ADDENDUM NO. 3

Date February 18, 2025

Kelso School District

Coweeman Middle School Cladding Replacement

4 EXTERIOR ELEVATION - ART & SHOP - EAST (RECLAD)
R114 1/8" = 1'-0"

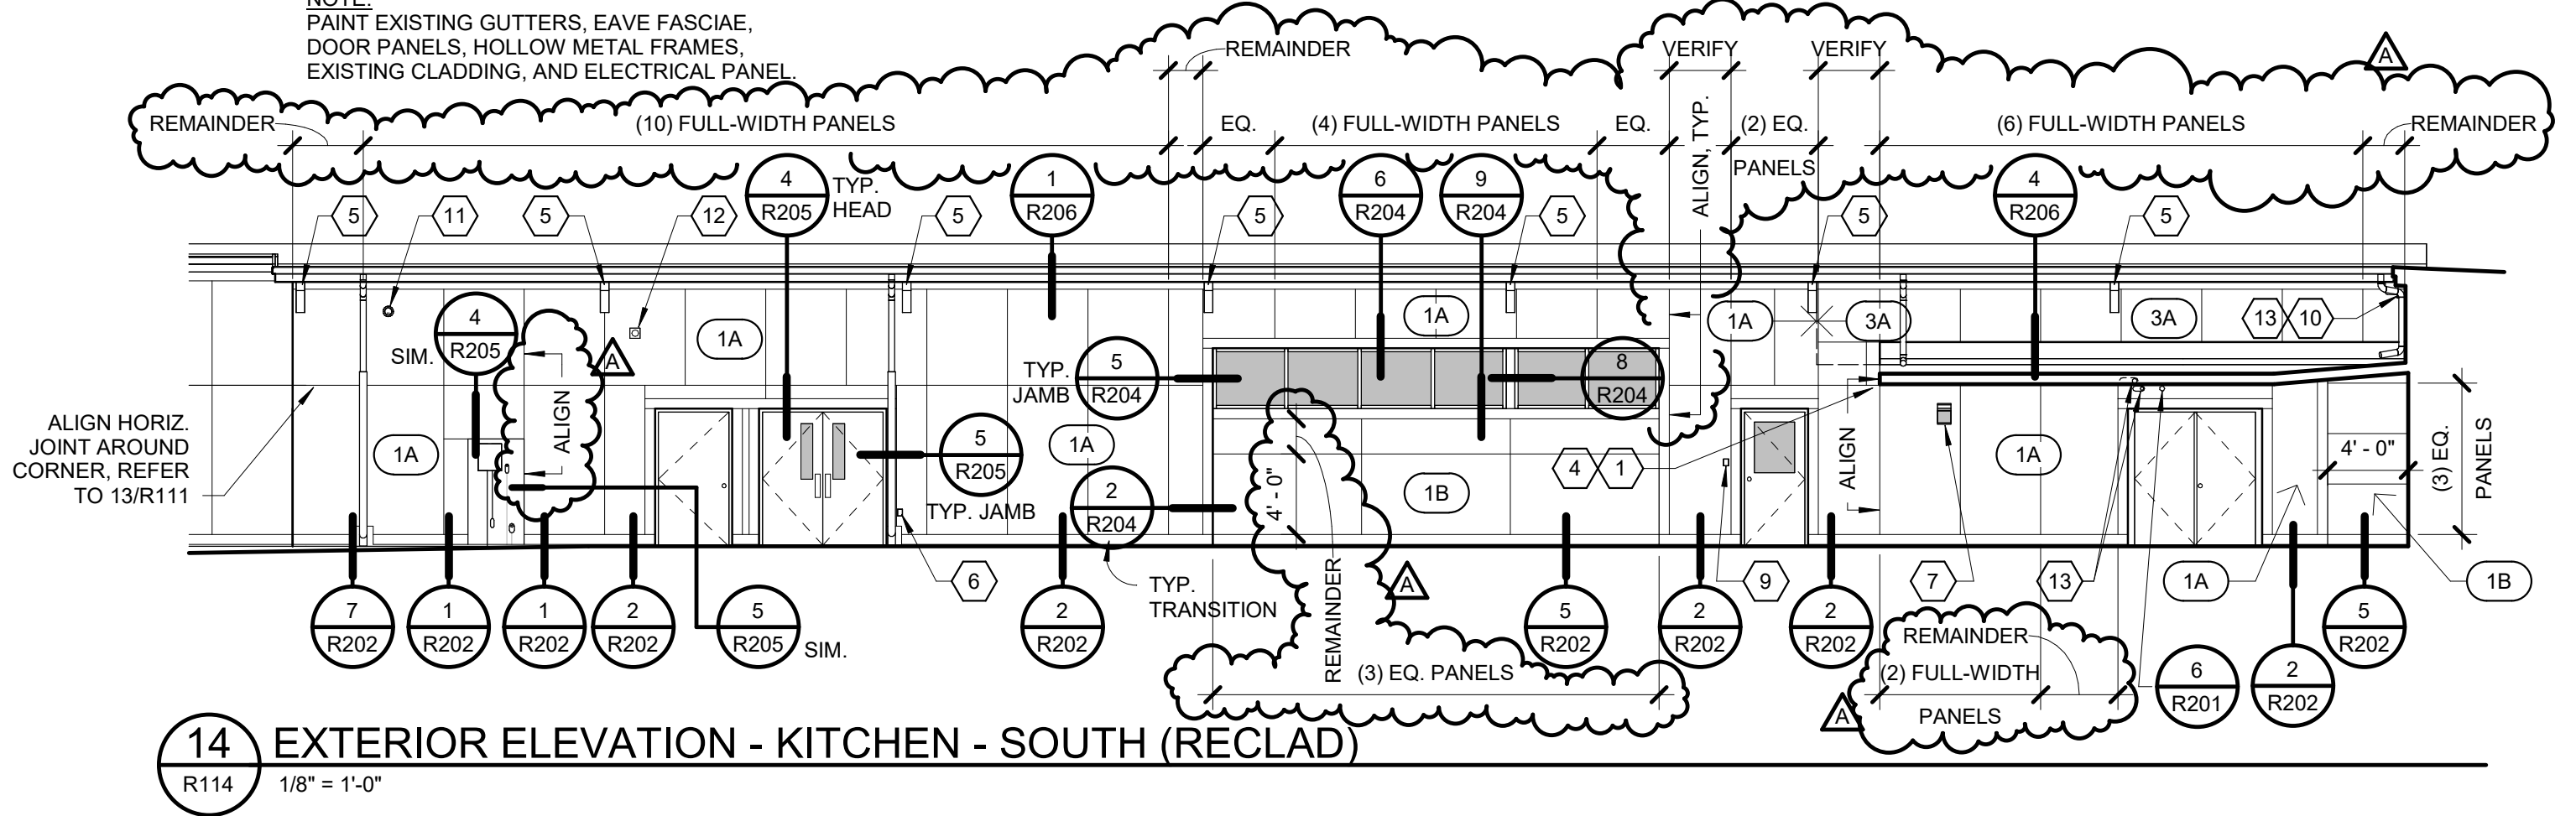
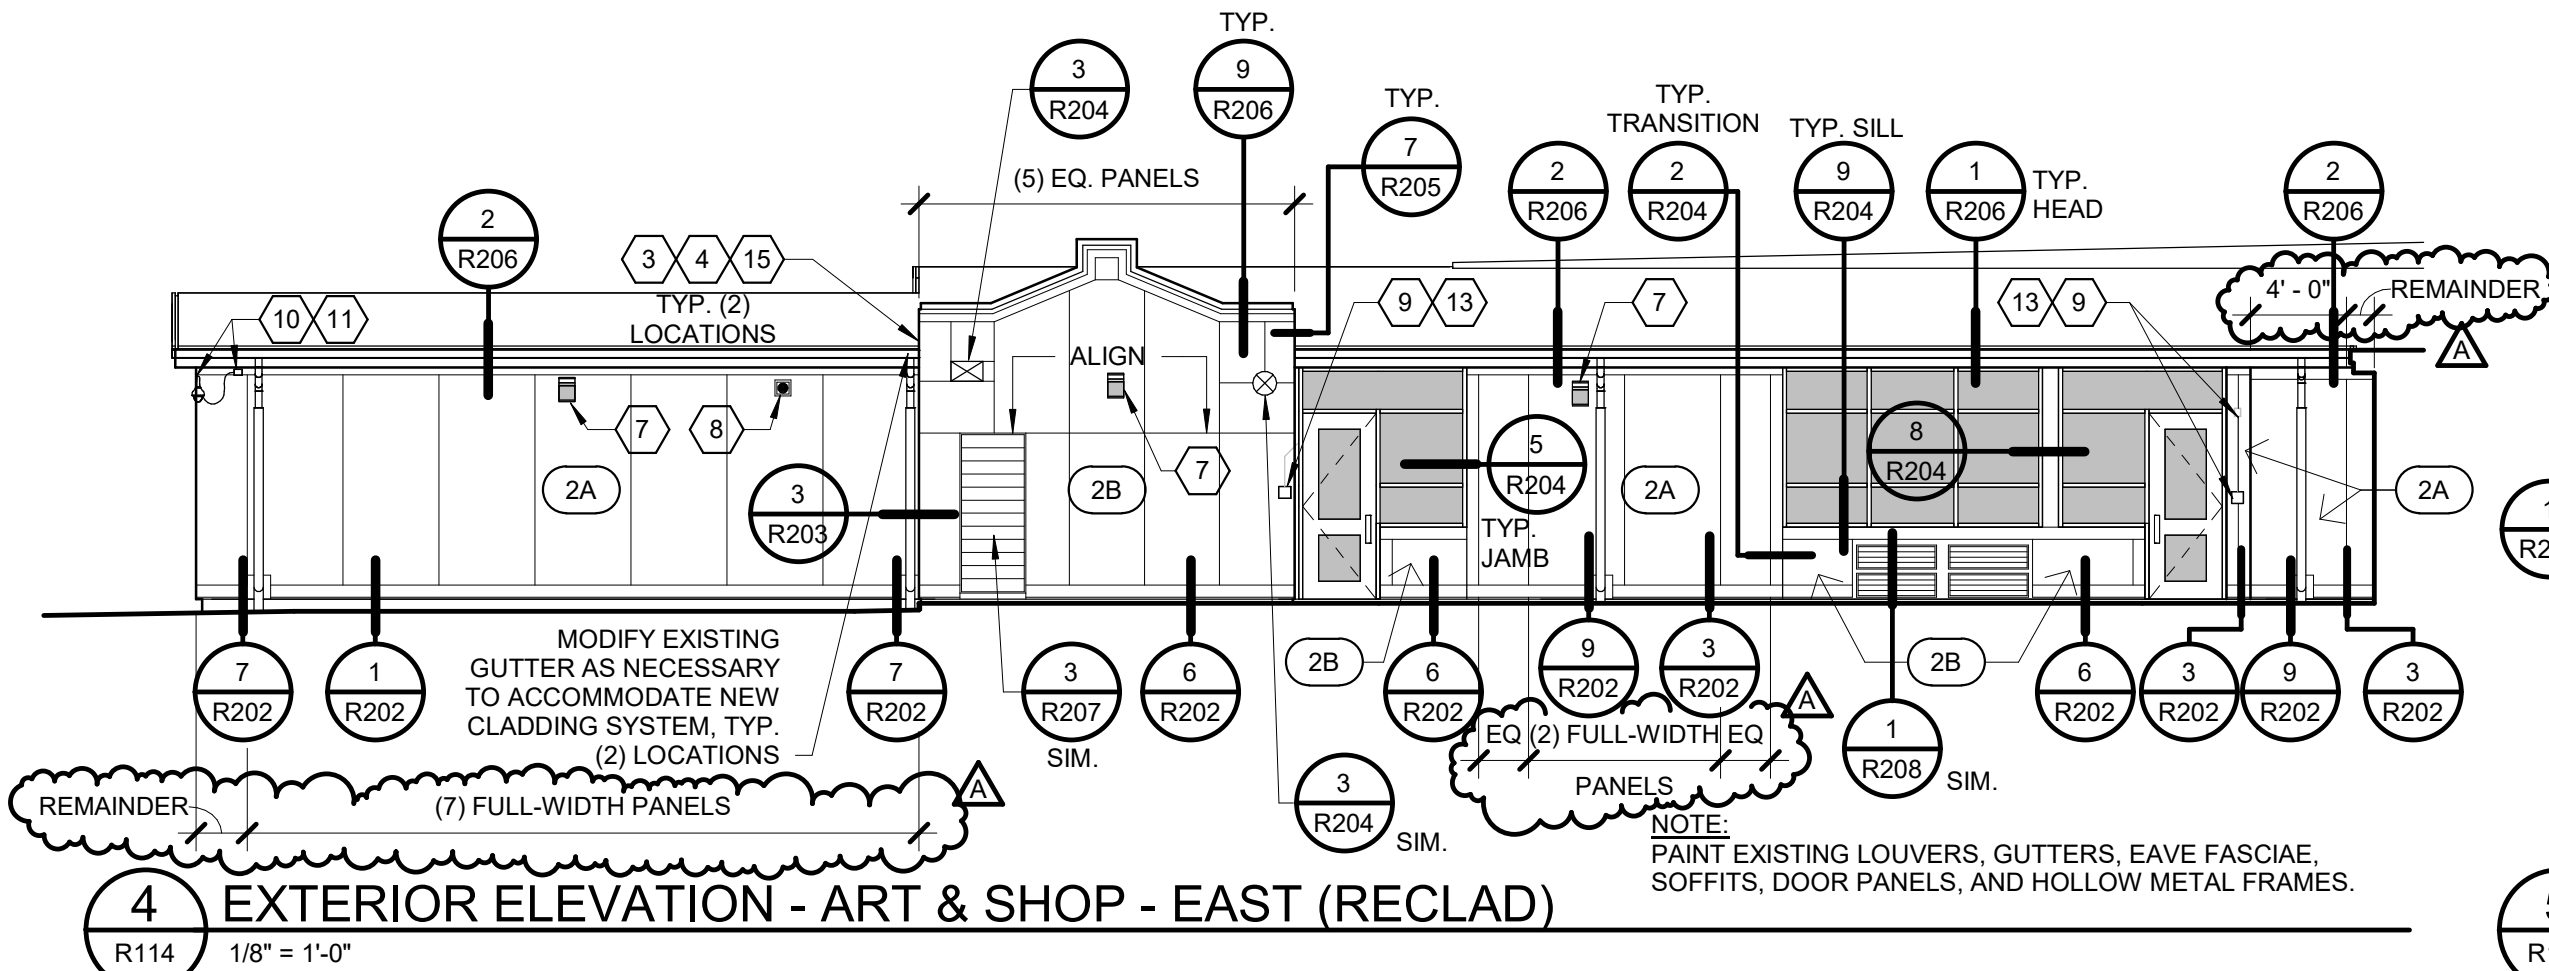
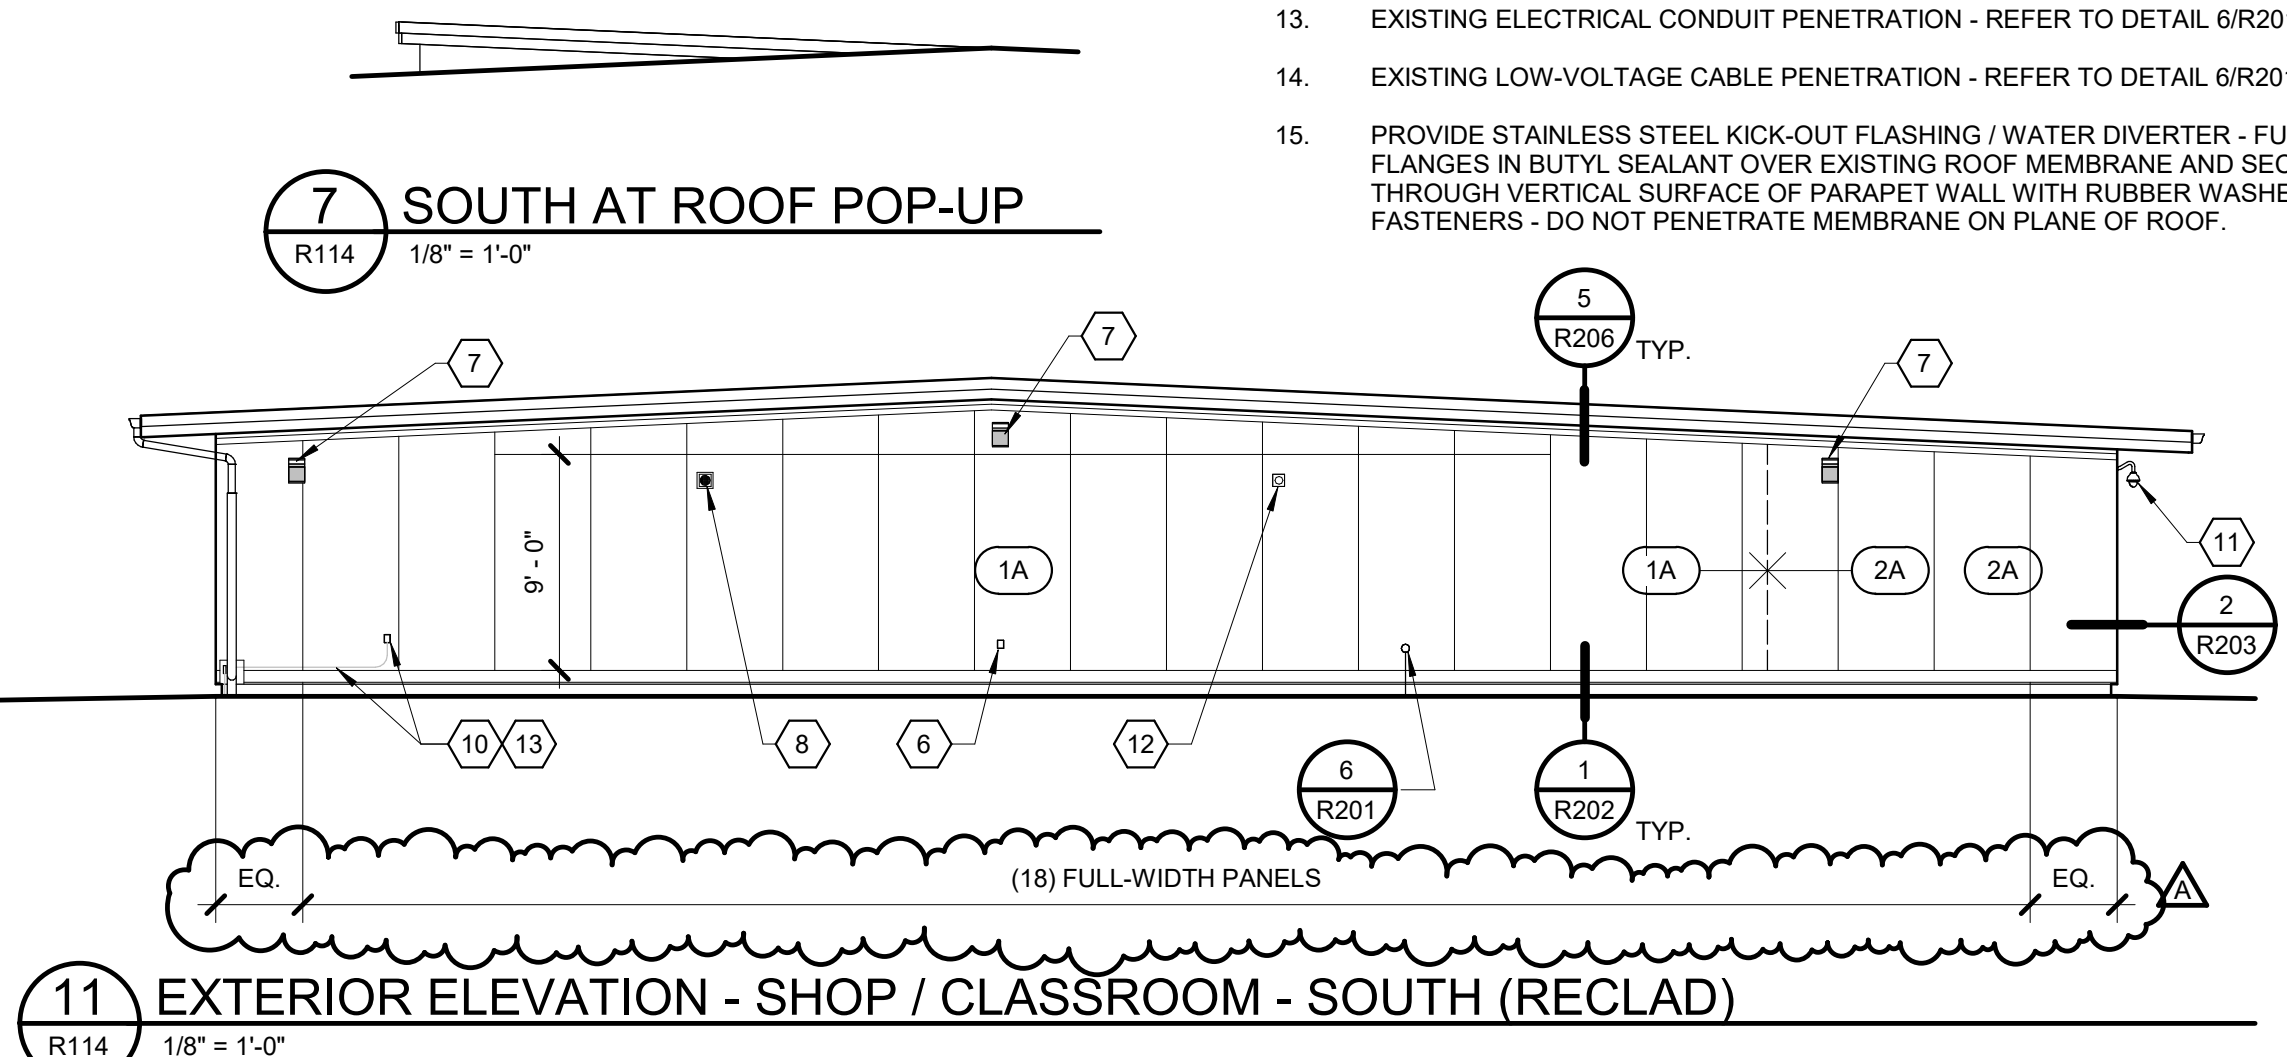
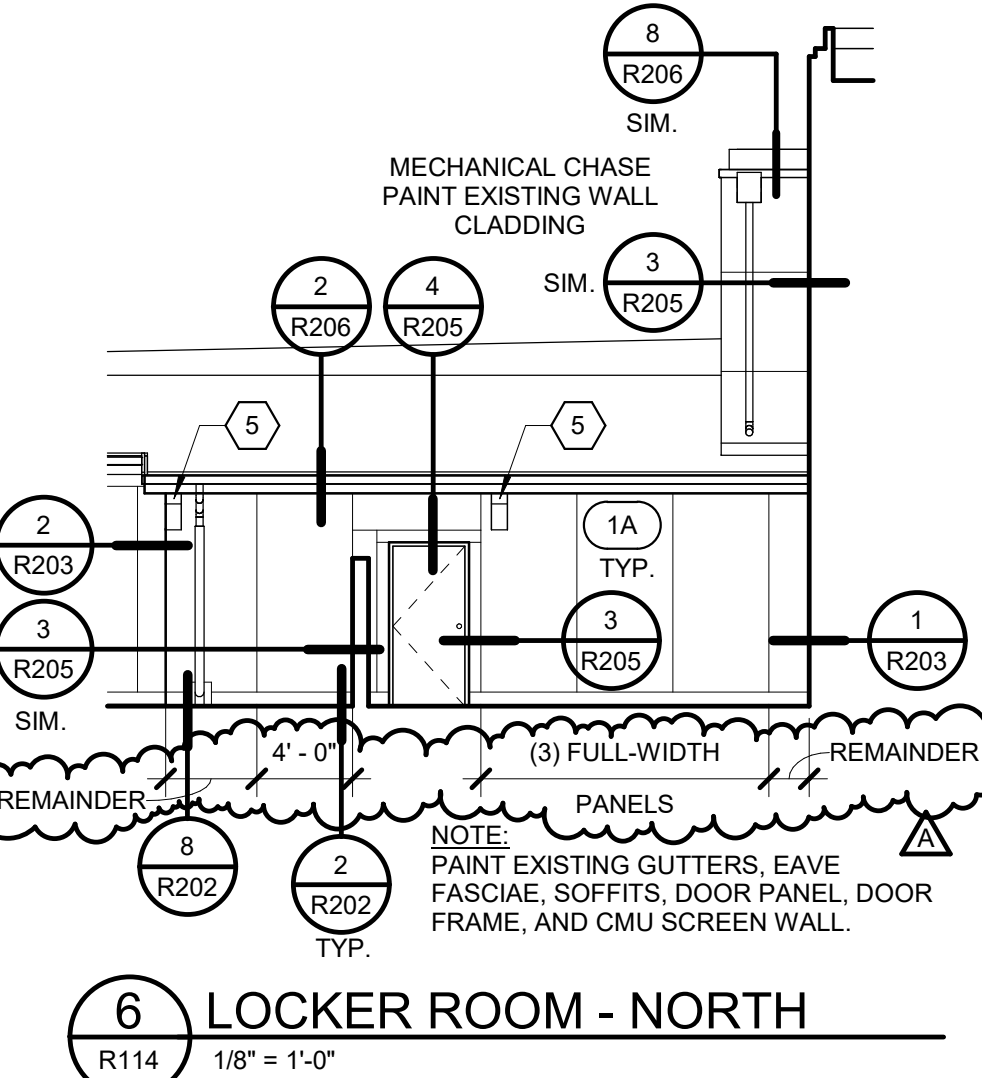
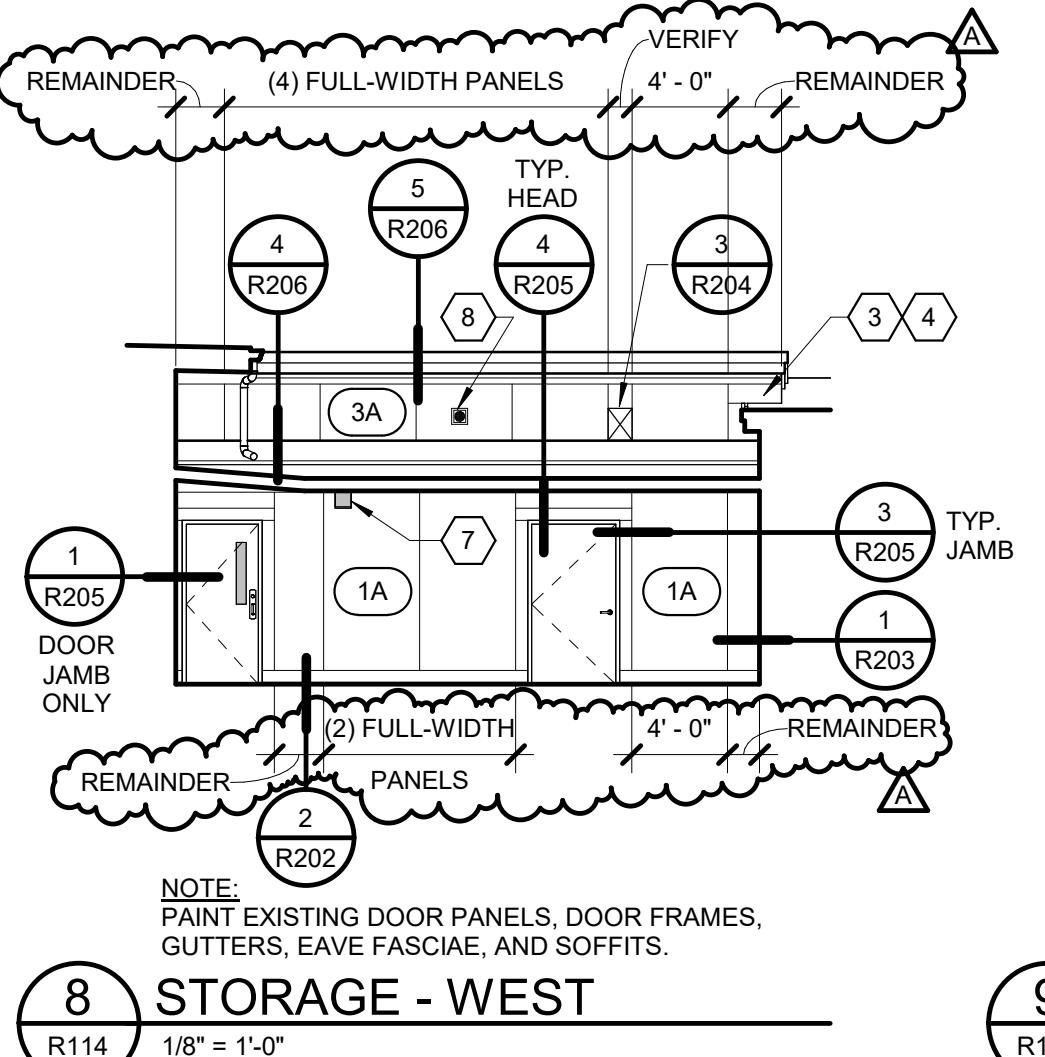
3.04	<i>Drawing Sheet R114</i>	Replace sheet with attached revised Sheet R114. Note the following changes: <ul style="list-style-type: none">• Altered layout of fiber cement panels to reduce the need for cutting panels to custom widths.• Added Addendum No. 3 revision identifier.
